Attachment 3

**GNF Response to EU
Request for Additional Information (RAI)**

Response to EU Technical Issues

Figure A-1 – Drop and Puncture Test Orientations

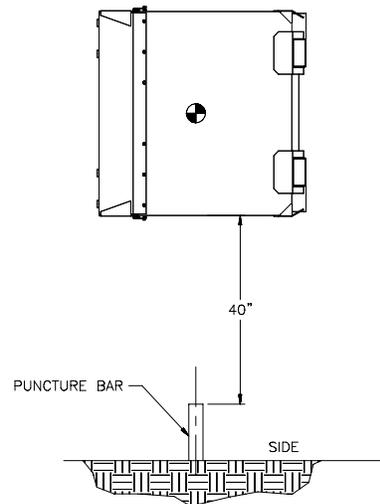
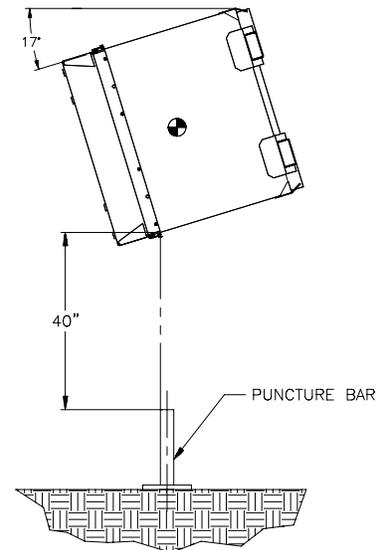
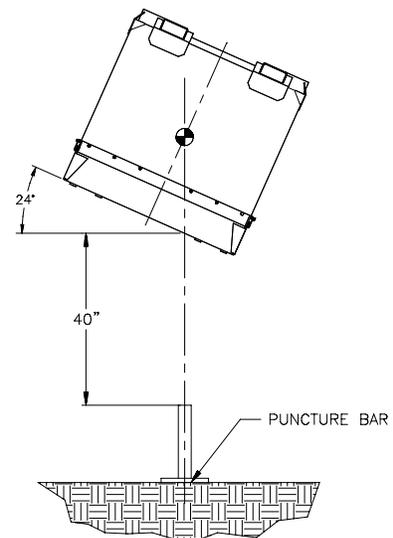
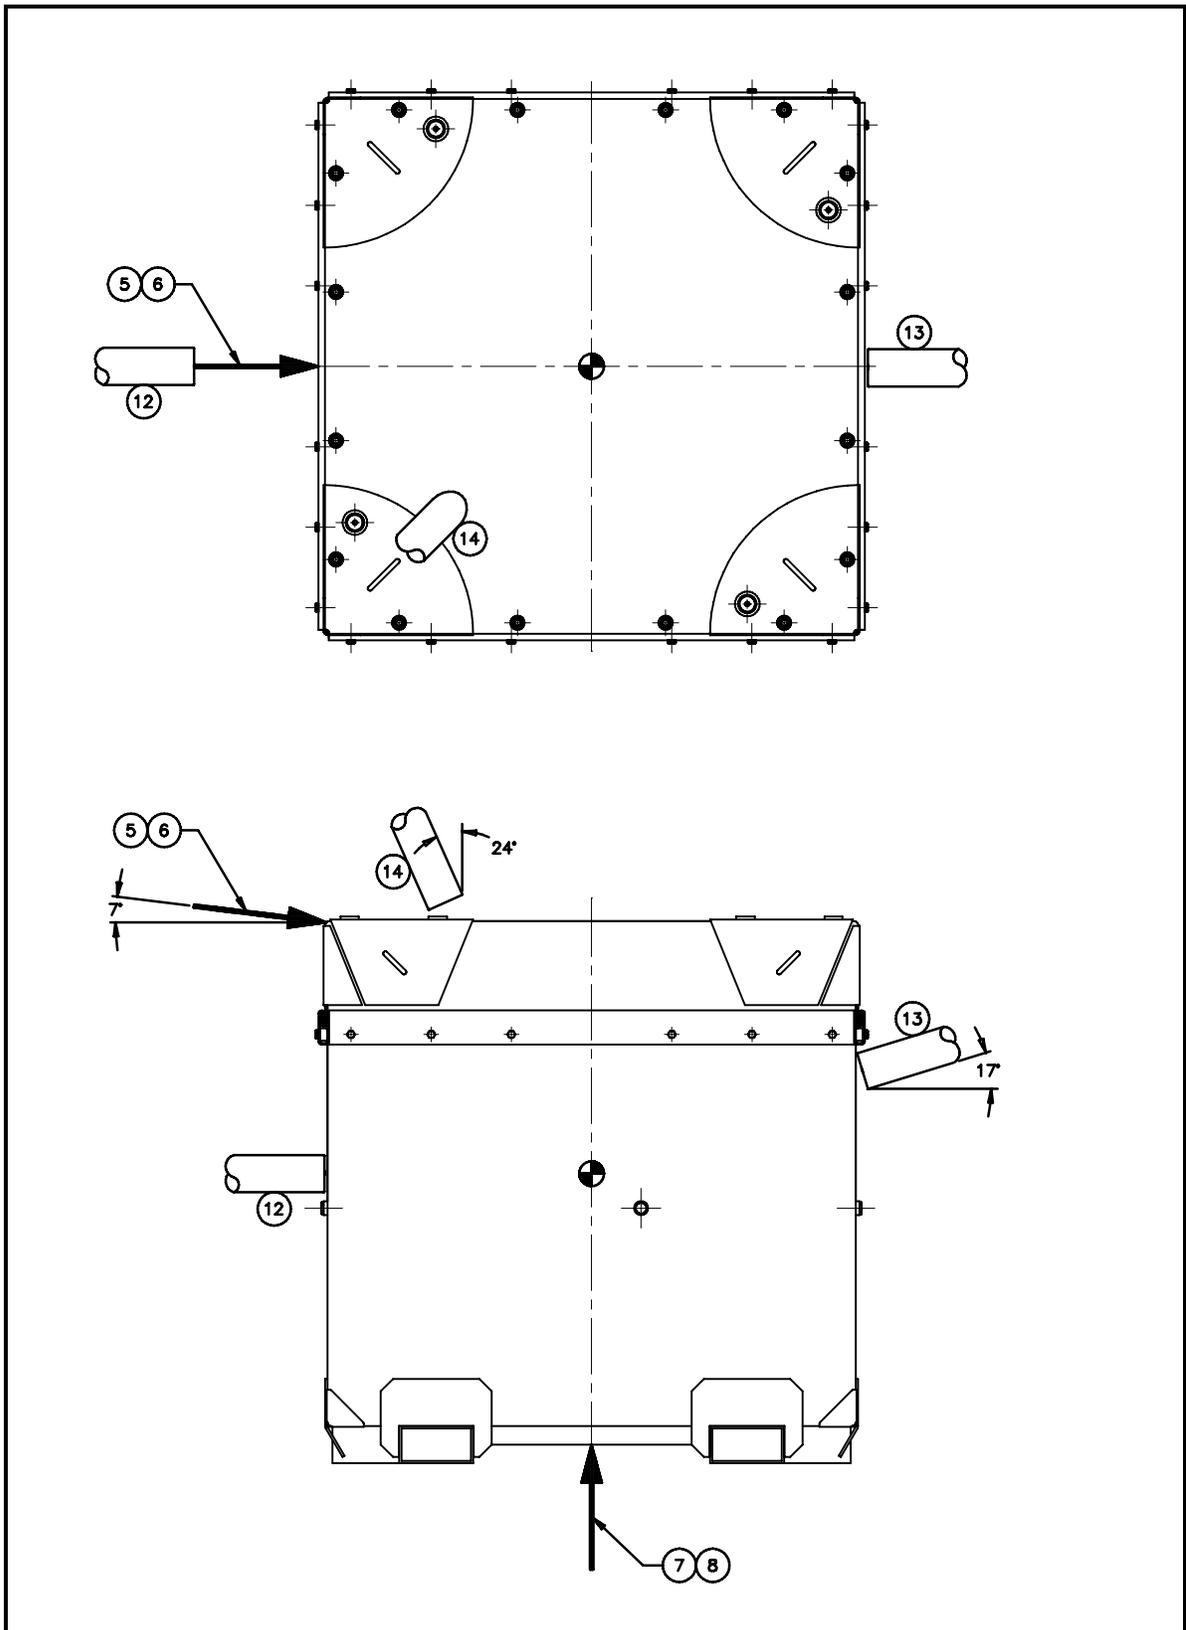
6. *Have you assessed the scenario whereby a package is dropped onto a puncture bar at an oblique orientation, so that it hits the middle of a lateral surface? If not, this assessment could be achieved by performing a finite element calculation with the intention of showing that the damage would be less than for the drops already considered. The reason for this additional scenario is that the potential for a larger opening of the package before the fire test could have an important effect on the temperature of the polyurethane foam, polyethylene and the inner bottle which could consequently have an effect on their composition and geometry.*

GNF performed three puncture tests to specifically determine whether tearing of the outer shell occurs during impact and maximize damage to the thermal protection design features of the package. Attachment A summarizes the results for puncture test 12, 13, and 14 from Appendix 2.10.1 of the NPC SAR. Figure A-1 shows the impact orientations for each puncture test. Figures A-2 through A-7 provide photographs of the test preparation and post-test results. The following table is a summary of the puncture test setup and results. Penetration tests for CTU (4), #13 and #14 are most applicable to the question.

Figure A-4 shows the cumulative damage of two consecutive puncture tests. The lower indentation is the result of Test 13 and the upper indentation is the result of Test 12. Additionally, Figure A-7 shows the damage following the oblique drop onto the lid. All three drops were performed at -40°C, which reduces the ductility of the stainless steel shell. Because the testing was performed at extreme cold temperatures and cumulative damage is considered, no further analysis is justified.

Puncture testing experience indicates that thin metal skin is more susceptible to tearing (puncture) when higher density crushable materials that provide support as in the case of the NPC lid back it. Therefore, the oblique puncture on the lid is predicted to be the most damaging orientation because the lid contains significant 40# density foam and is more rigid than the sides of the package. The following figures are extracted from the SAR for the package.
